## AISIN 6

### DELAY OR SLIP IN DRIVE

## AISIN 6 DELAY OR SLIP IN DRIVE

### 2008 & EARLIER K1 DRUM

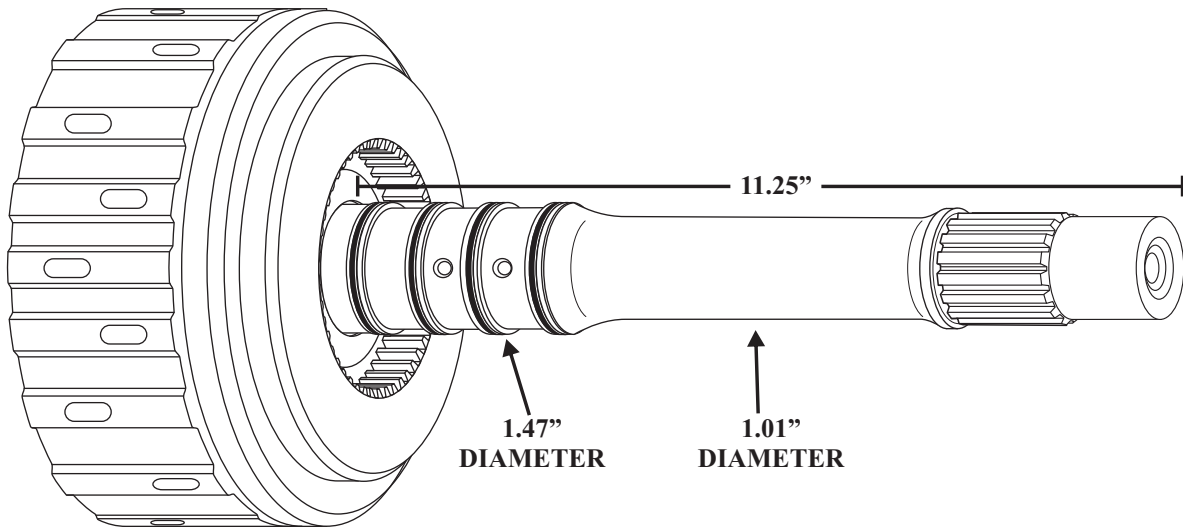
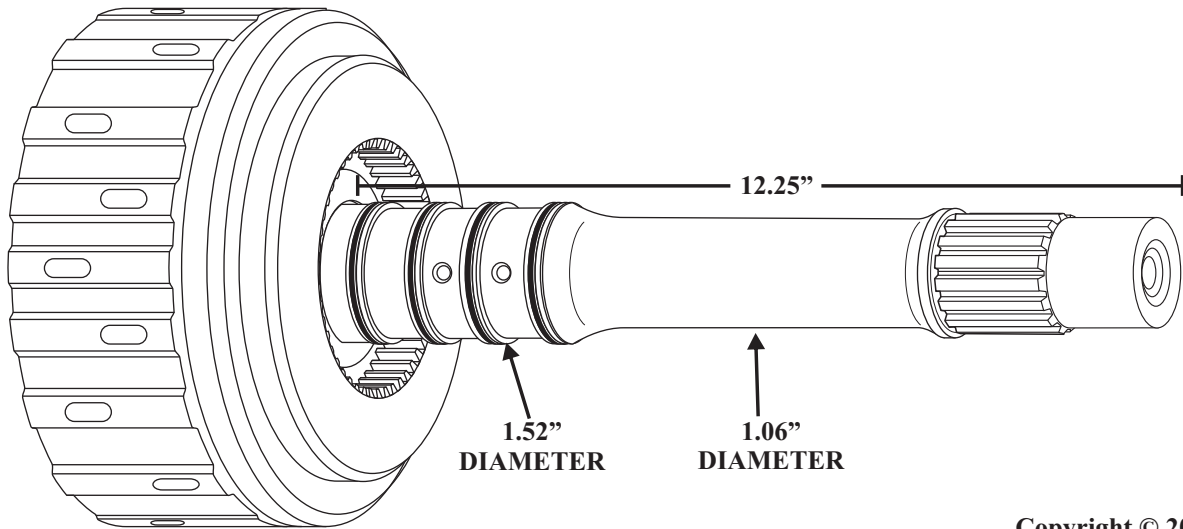
**CAUSE:** The four sealing rings that were installed onto the K1 Drum input shaft were undersized by .050".

2008 and earlier K1 input shaft sealing ring area diameter is **1.470"** in diameter and the remainder of the input shaft is 1.01" in diameter (See Figure 1). The sealing rings for this K1 drum can be **1.433" to 1.440" in diameter**.

The 2009 and later K1 input shaft sealing ring area is **1.520"** in diameter and the remainder of the input shaft is 1.06" in diameter (See Figure 3). The sealing rings for this drum can be 1.483" to 1.490", approximately a .050" difference.

As an additional service note, the tilt cab truck K1 drum is 11.25" tall (See Figure 1). The K1 drum for a Dodge application is taller than the tilt cab truck version. The Dodge K1 drum is 12.25" tall (See Figure 3).

**CORRECTION:** Beginning with the 2009 model year, the diameter of the input shaft became .050" larger in diameter. The pump cover/stator shaft was also changed to accommodate the larger diameter input shaft.

### 2008 & EARLIER PUMP COVER/STATOR SHAFT

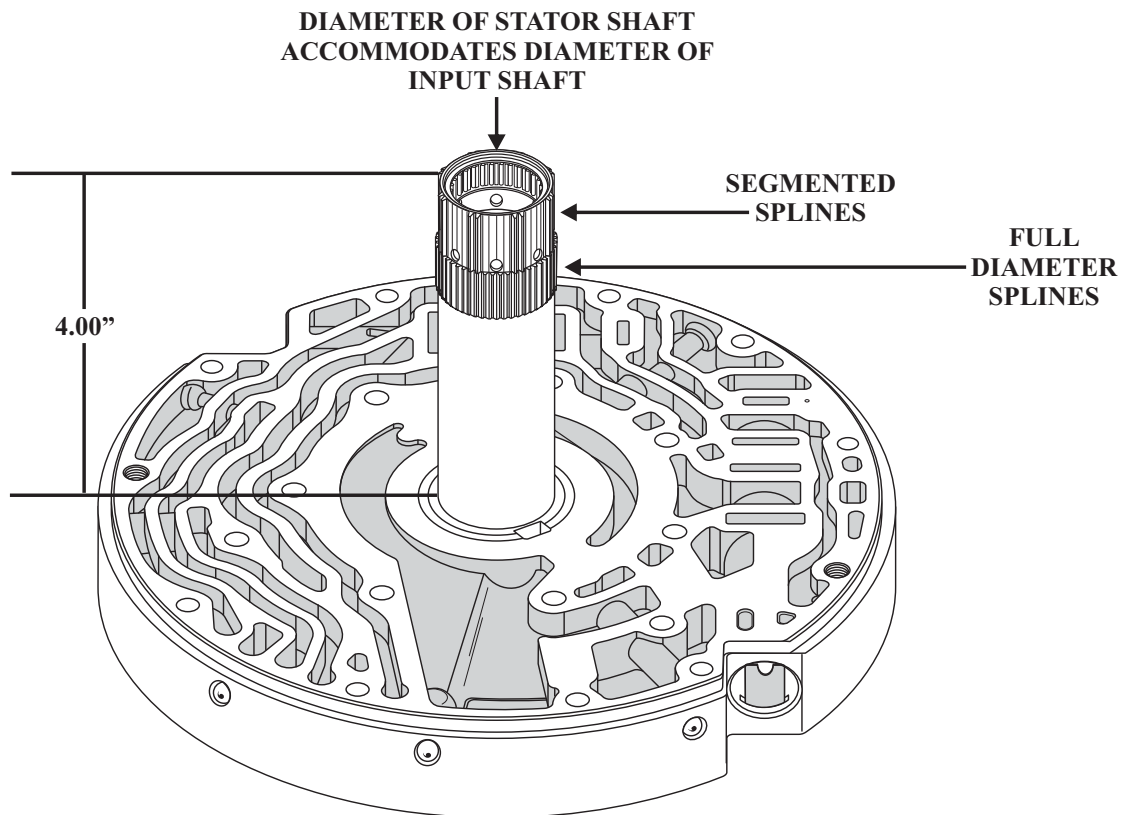
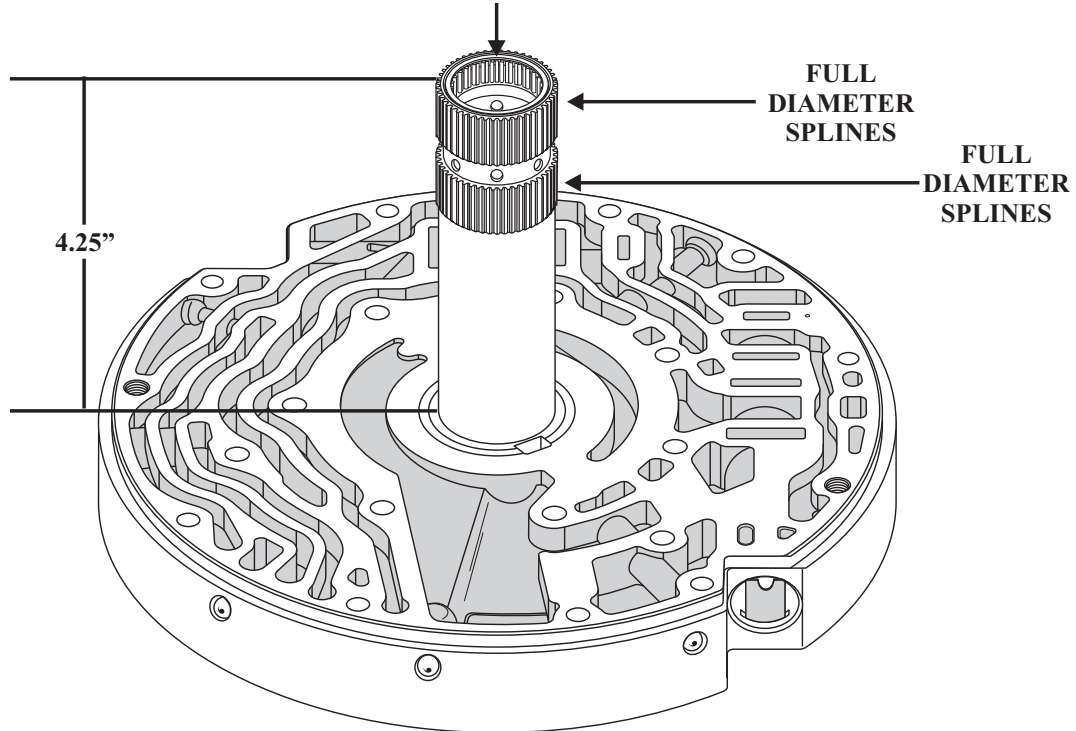
Also notice that the splines at the tip of the stator shaft are different for a Tilt Cab Truck and the stator shaft 4.00" tall (See Figure 2), application then the splines for the tilt cab applications and the stator shaft is 4.25" tall, See Figure 4.

DIAMETER OF STATOR SHAFT  
ACCOMMODATES DIAMETER OF  
INPUT SHAFT
